Town of Hilton Head Island Regular Design Review Board Meeting

Tuesday, February 28, 2012

AGENDA

DESIGN TEAM/DRB COMMENT SHEET

EAST ELEVATION
 1/16" (082 XII PLOT)

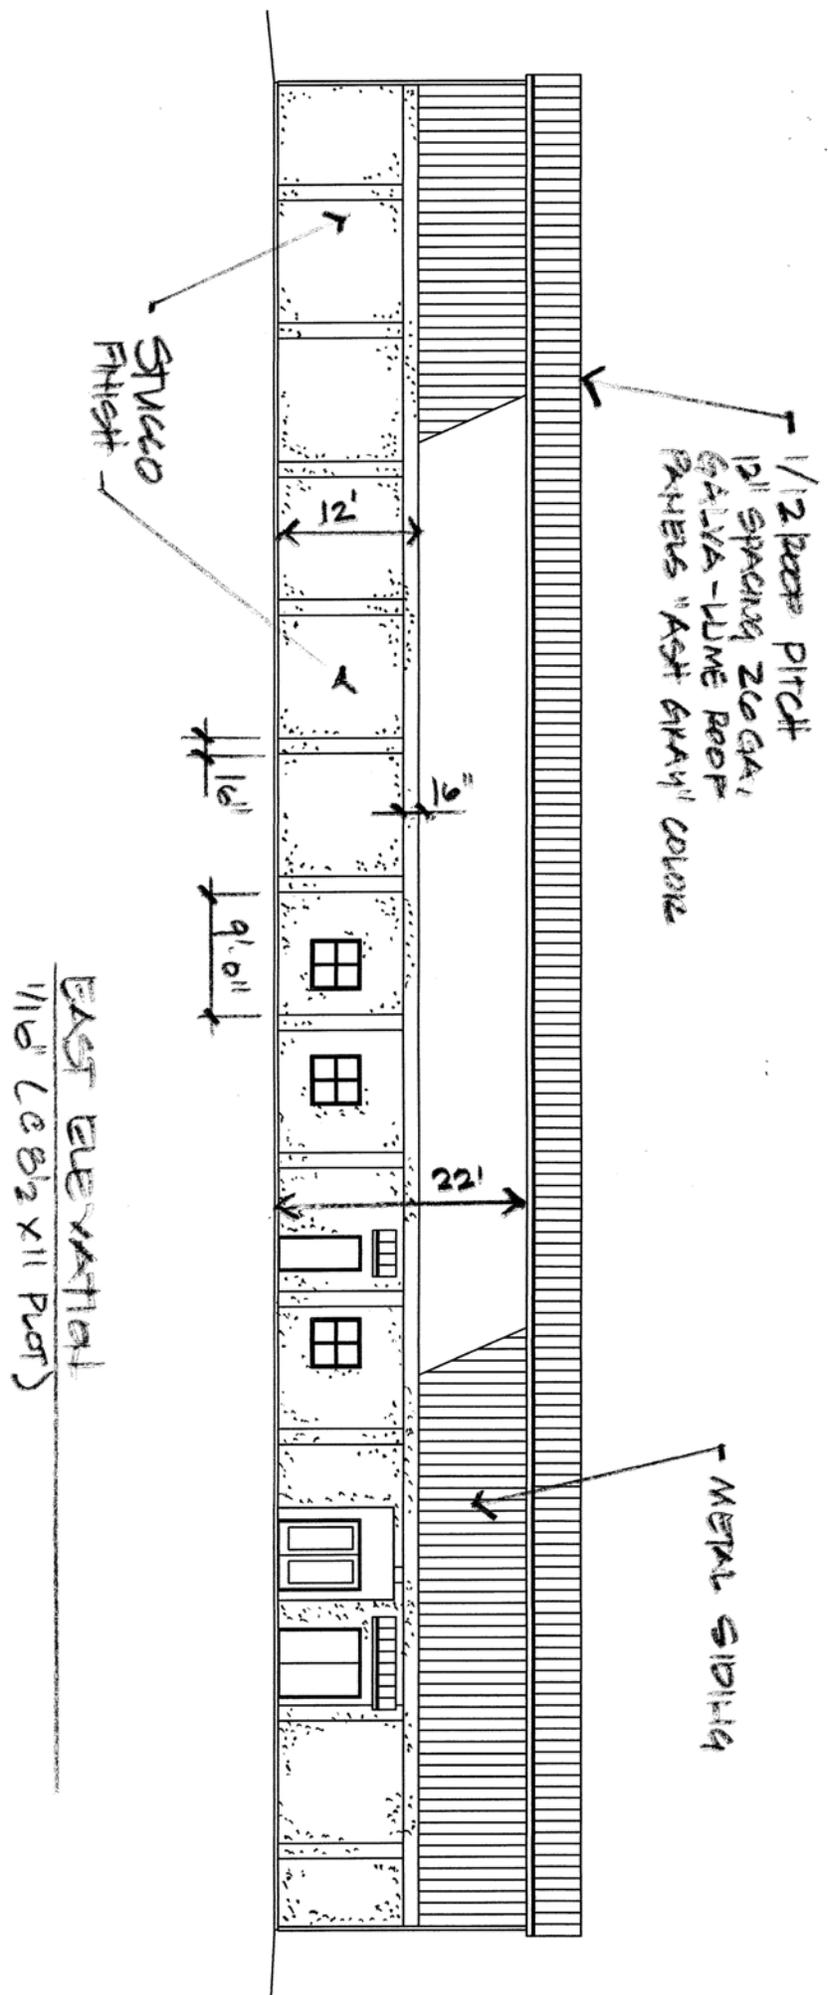
All facades are have equal design characteristics	<input type="checkbox"/>	<input checked="" type="checkbox"/>	<input type="checkbox"/>	This submittal brings the project closer to what the Board had asked for, but the effort should continue on all four sides. A building this size has permanence and will take some investment. Value engineering to this extent will be glaring for some time
Avoids monotonous planes or unrelieved repetition	<input type="checkbox"/>	<input checked="" type="checkbox"/>	<input type="checkbox"/>	On two sides
Has a strong roof form with enough variety to provide	<input type="checkbox"/>	<input checked="" type="checkbox"/>	<input type="checkbox"/>

Project is moving closer to what the Board's comments requested for approval, although it only addresses two sides. The notion of entertaining a building of this size and material composition, lacking good fenestration or roof forms as well, shows a good deal of flexibility by the Board. The same flexibility should be shown by the applicant in making it more compliant with the Design Guide, rather than dressing up the two most visible sides. No side of this building is invisible.

Sheet Title:
 EXTERIOR ELEVATIONS

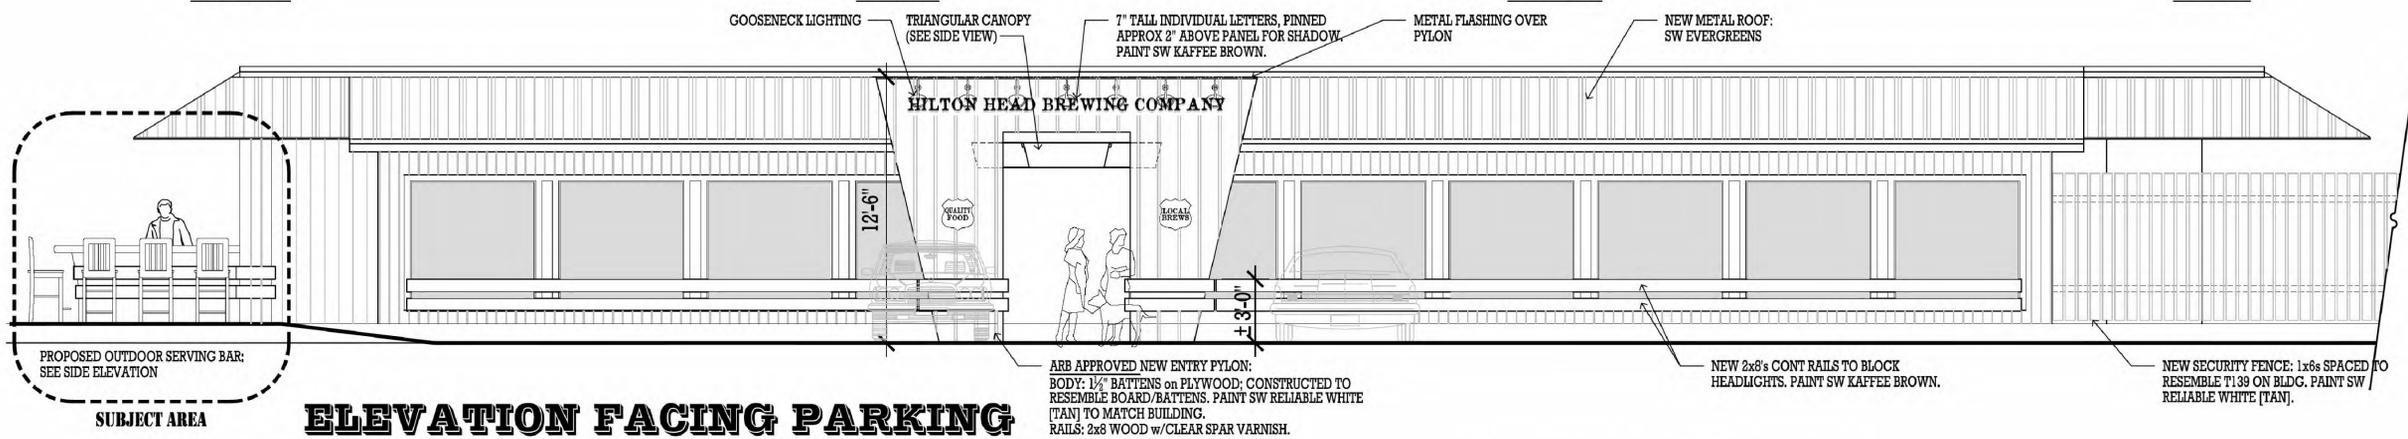
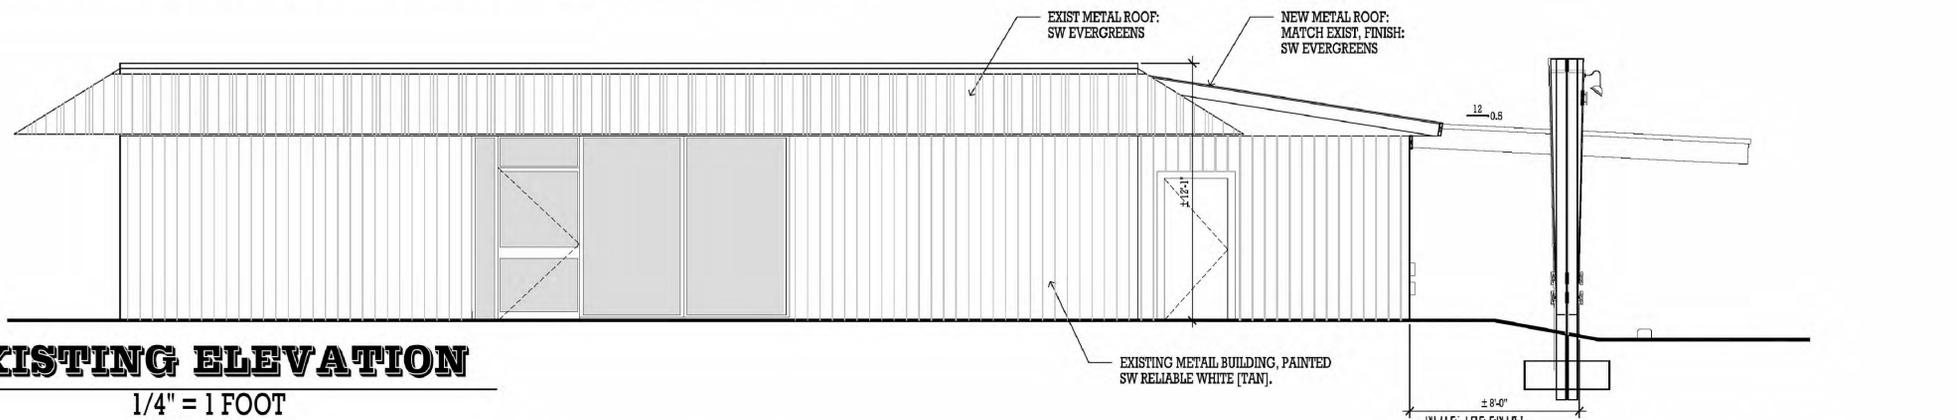
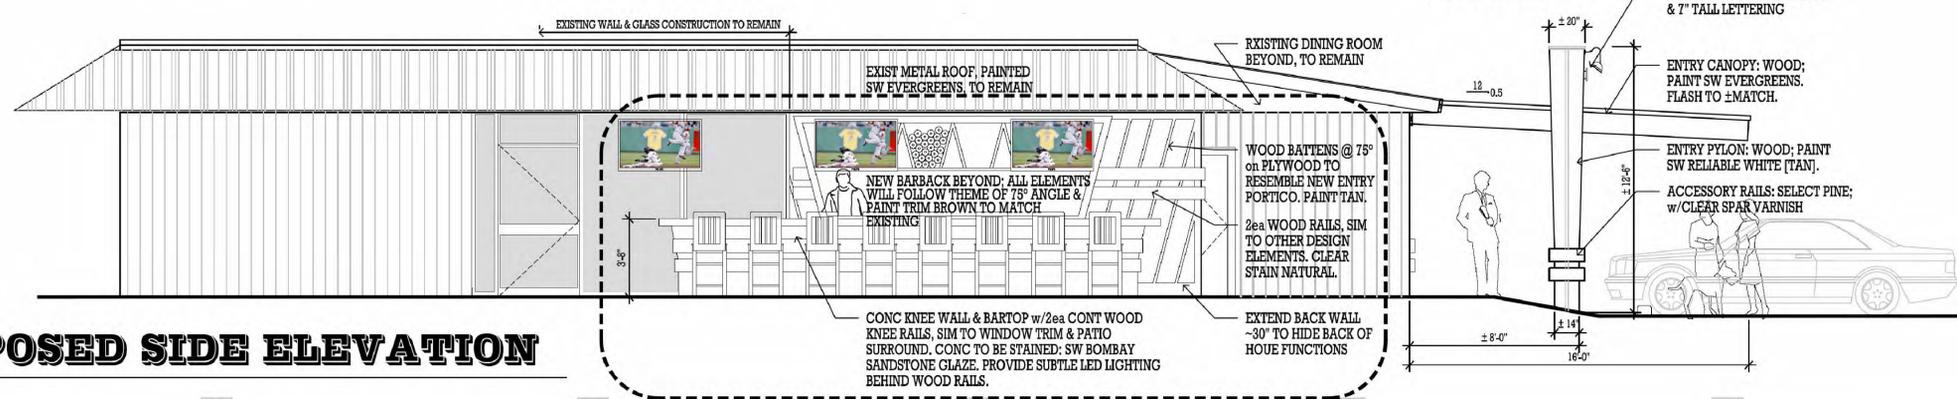
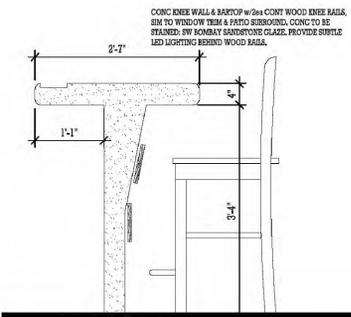
Project provides an outdoor bar element to the previously approved expansion. Materials, forms, details and finishes are consistent with the rest of the design

- Applicant should provide some form of finish sample for the concrete bar's stain
- All wood stain finishes should match previously approved
- Plywood call-out should be Hardi-board, or equivalent, per the last approval
- Some form of through section should be submitted to clarify how the new bar back interfaces with all the electric equipment currently coming through the exterior wall

SITE PLAN
SCALE 1/8" = 1'-0"

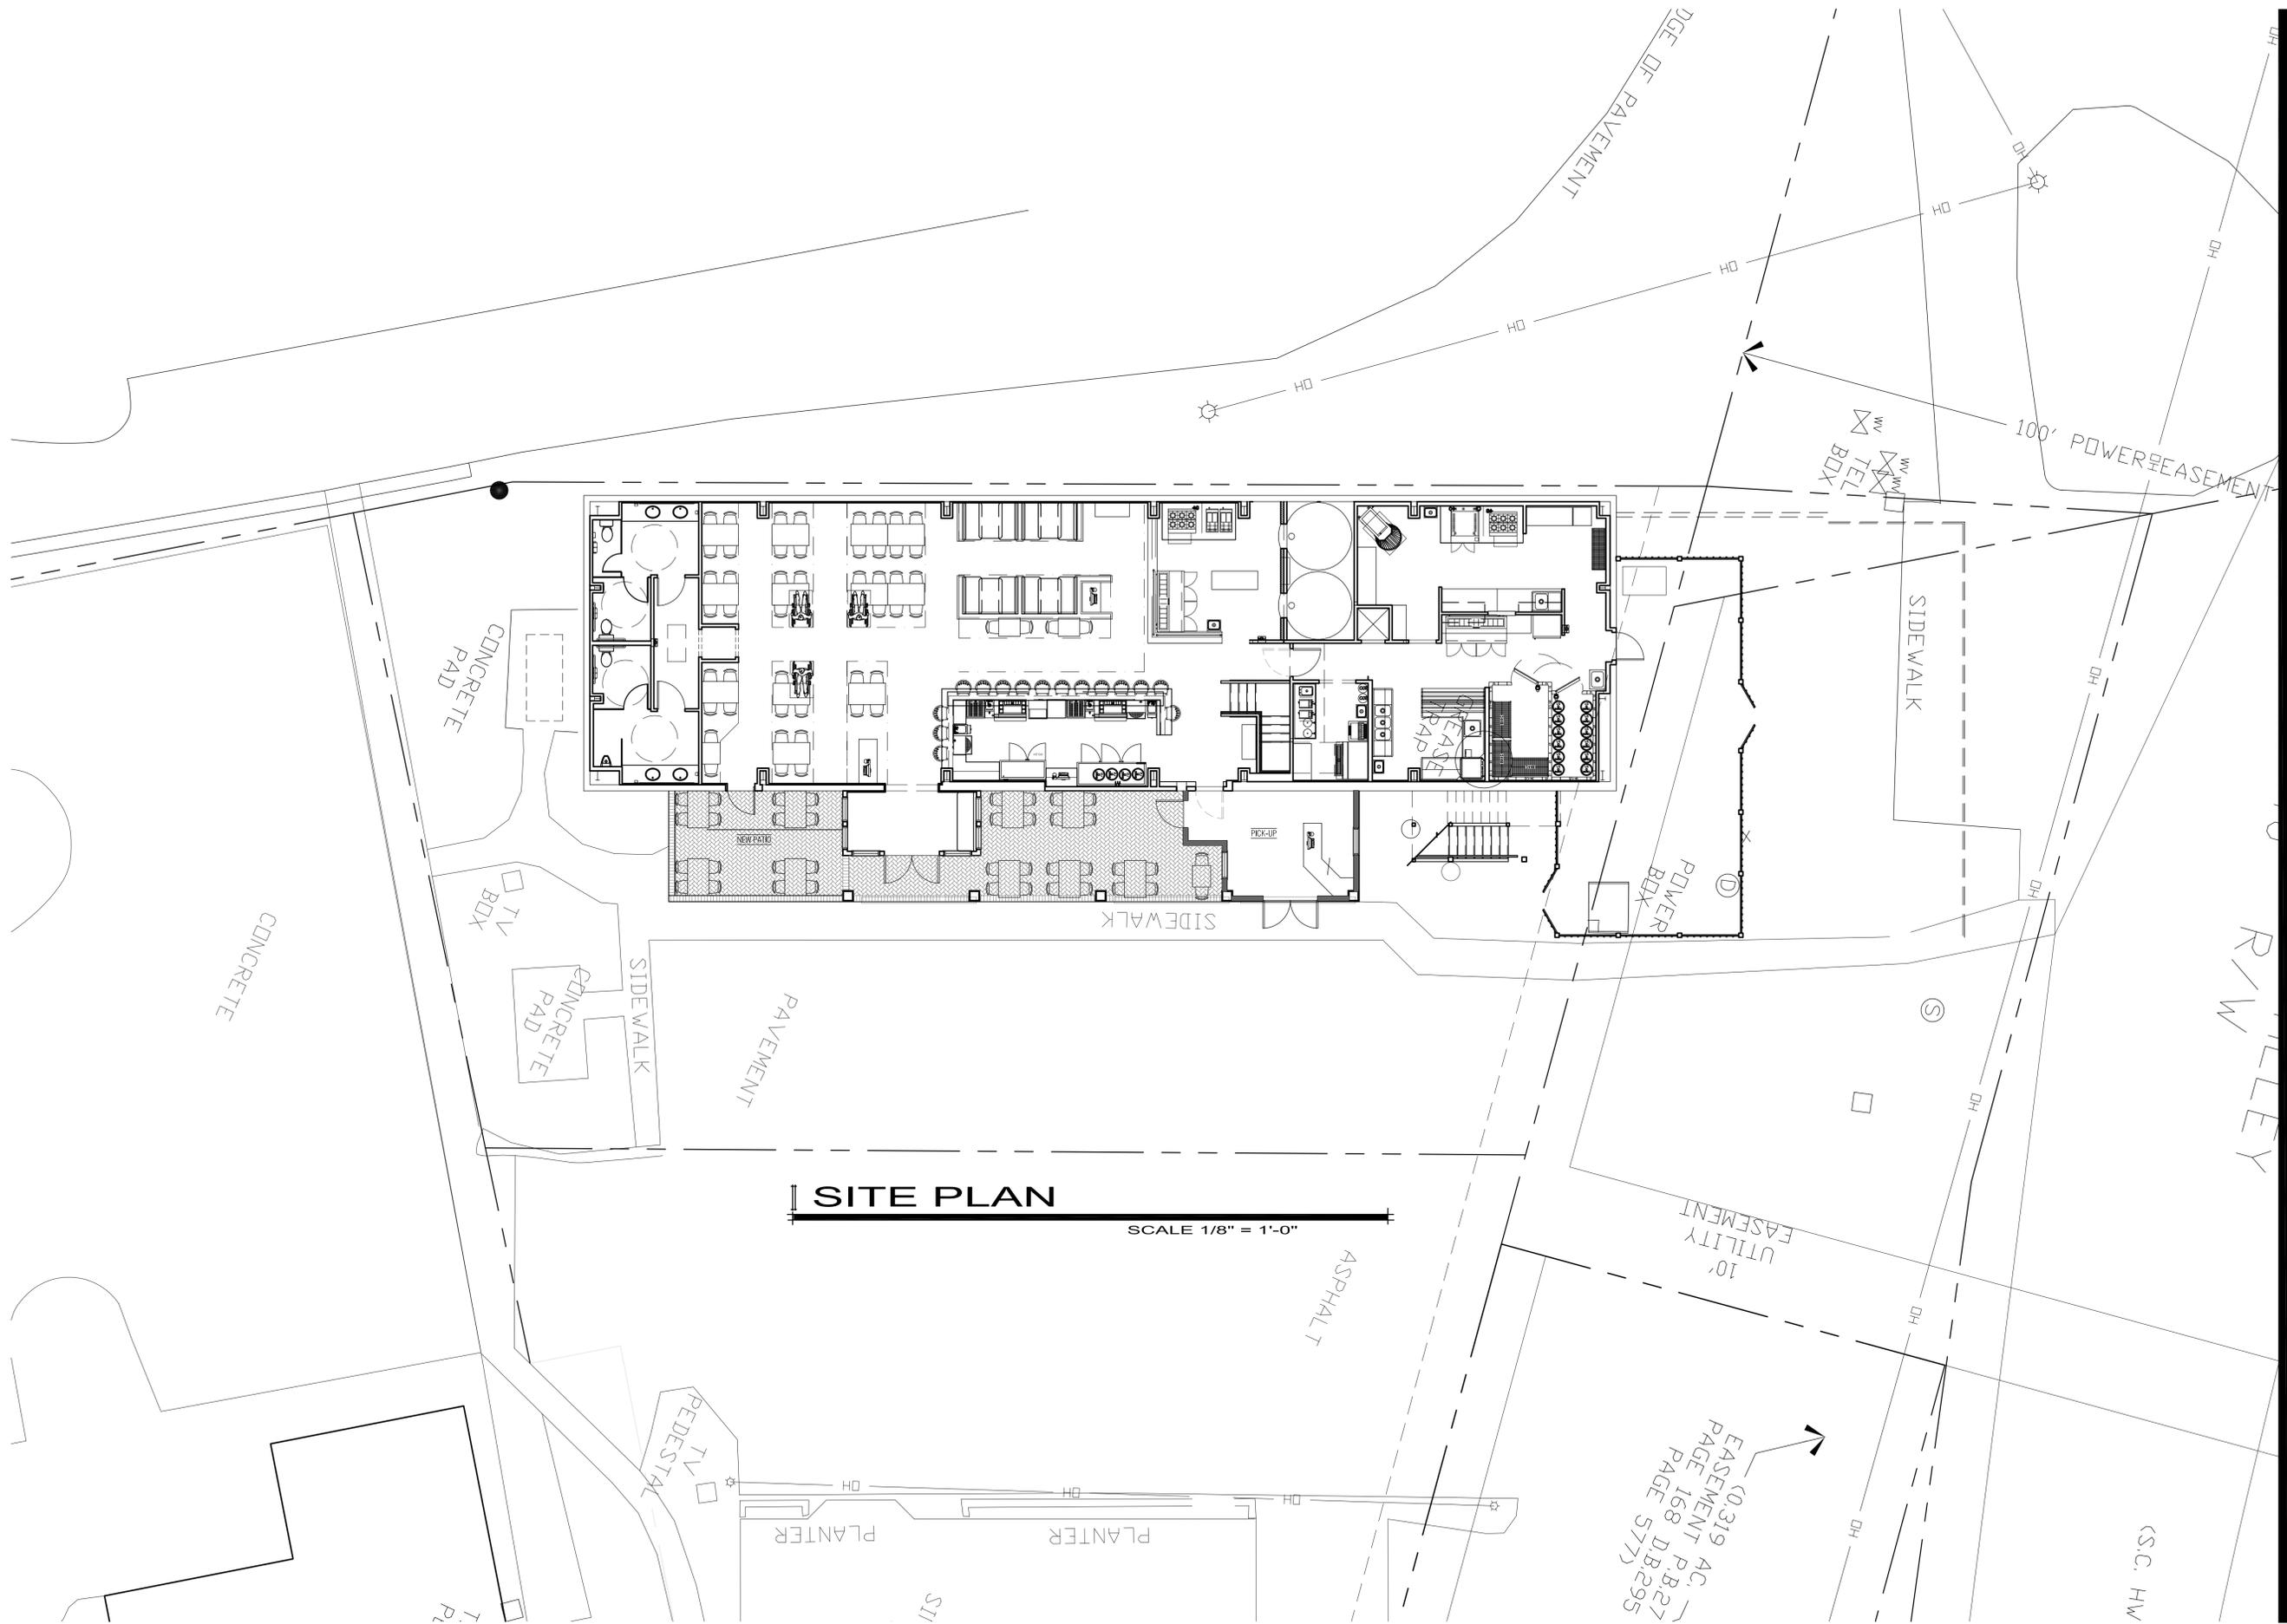
Project utilizes some of the existing covered outdoor patio as an enclosed space for carryout pickup and then reclaims the lost space with an expansion of the patio with uncovered seating. The materials, details, finishes, etc. all match the existing redevelopment effort. The through section would indicate the current column-turned pilaster would have no depth relative to the wall, and maybe the overall integration and geometry of the two existing columns should be addressed.

The expansion might be better served, externally speaking, by expanding the existing entry element and refining its existing roof form. The proposed bump out creates an altogether separate, flat-roofed element and sort of a disconnected expansion of the outdoor seating, rather than two distinct and cohesive elements. This would take the carryout further from the kitchen, but might serve the main elevation better. The project is an approvable expansion, but perhaps the most basic comments listed above should be discussed at the meeting.
